EASTSIDE LIBRARY GUTTER AND SOFFIT REPLACEMENT

23-T00040/AP Q 49

ADDENDUM No. ONE (1)
TO
THE CONTRACT DOCUMENTS
FOR THE
Pre-Qualification for Construction Services under \$500K
IN
HERNANDO COUNTY, FLORIDA
SOLICITATION NO. 23-T00040/AP Quote No. 49
Eastside Library Gutter and Soffit Replacement

DATE: March 4, 2026
TITLE: Addendum No. 1 – Eastside Library Gutter & Soffit Replacement
REFERENCE: Hernando County - Bid Number 23-T00040/AP Eastside Library

SHEET TITLE
**SOFFIT AND
 GUTTER
 PLAN**

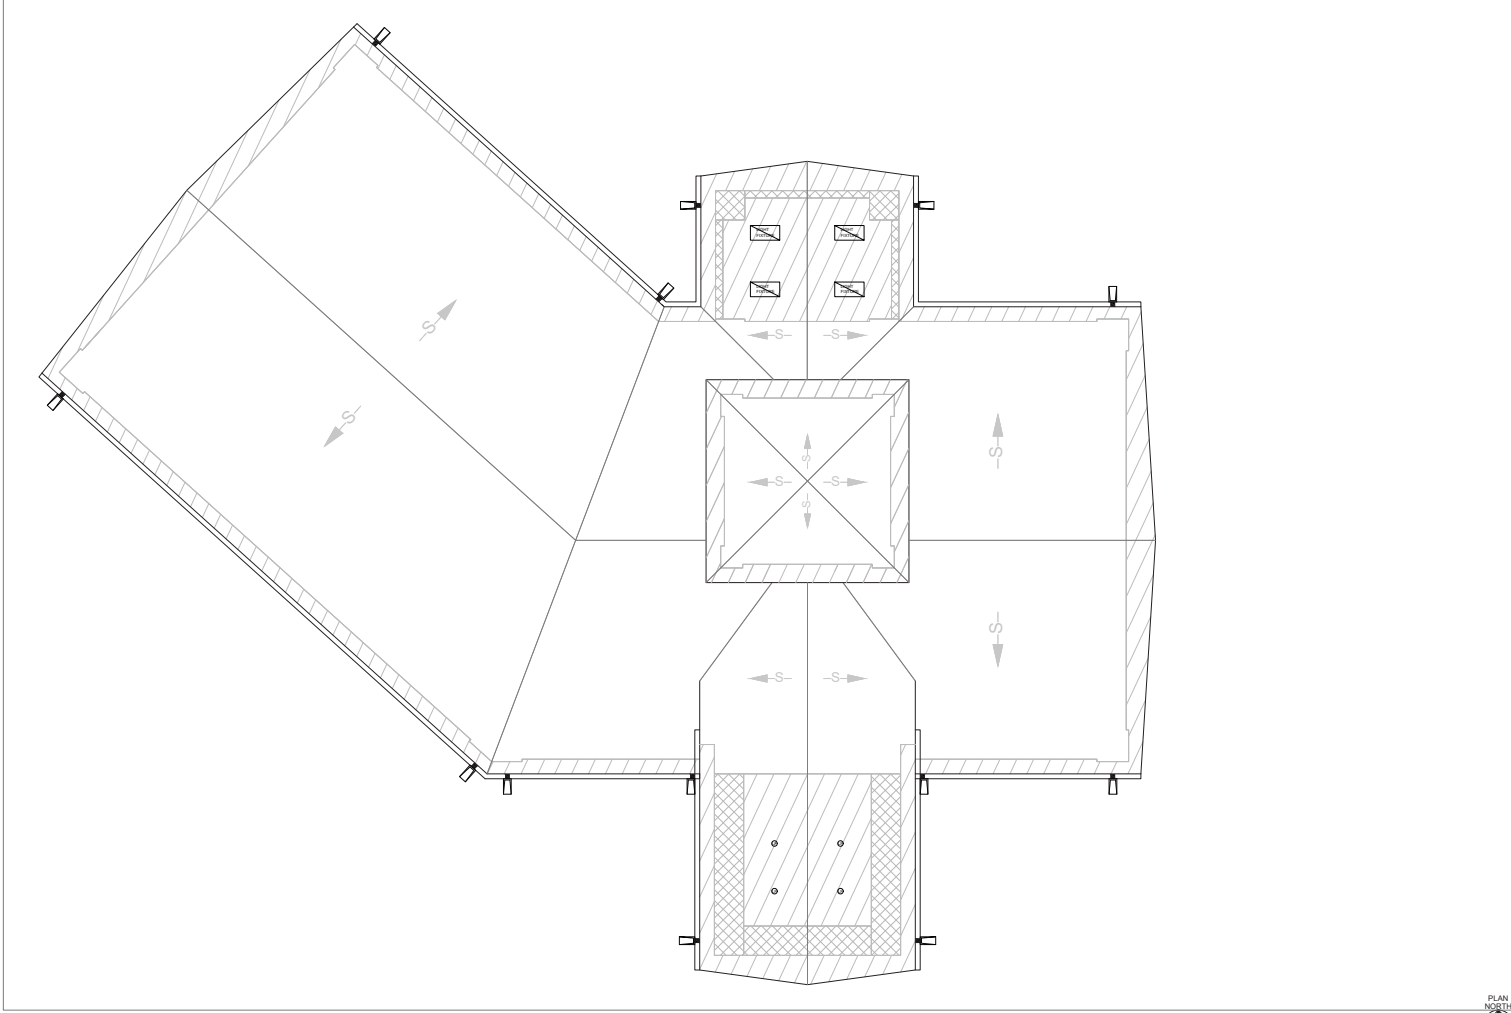
1. Addition to Section 2. SCOPE AND SPECIFICATIONS Item C. Installation of Exterior Components and Item D. Lighting Installation as follows with Appendix 1 to this addendum:

A. Install one 24"x24" access panel within the new soffit of the rear canopy location to allow for entry into the attic space. The access panel shall be constructed of aluminum and include a locking, spring-loaded door. The inside face of the panel shall be installed 20-inches from the rear exterior wall of the library and be mounted slightly off-center between the existing framing members that are currently spaced 24-inches.

B. In lieu of the previously specified "recessed LED Troffer electrical lighting fixture," please provide a surface-mounted LED lighting fixture as otherwise specified.

C. Existing Rear Canopy Soffit Junction Boxes:

1. Four of the existing junction boxes are to serve the new recessed lights as previously specified.

2. The one existing junction box that once served a ceiling fan is to be mounted on the underside of the new soffit area with a blank cover plate for future fan installation. The junction box and blank cover are to be installed at the center point of the canopy.

3. The one existing junction box that serves the exit sign is to remain. However, the conduit and box are to be coiled and secured to the existing attic framing and above the soffit.
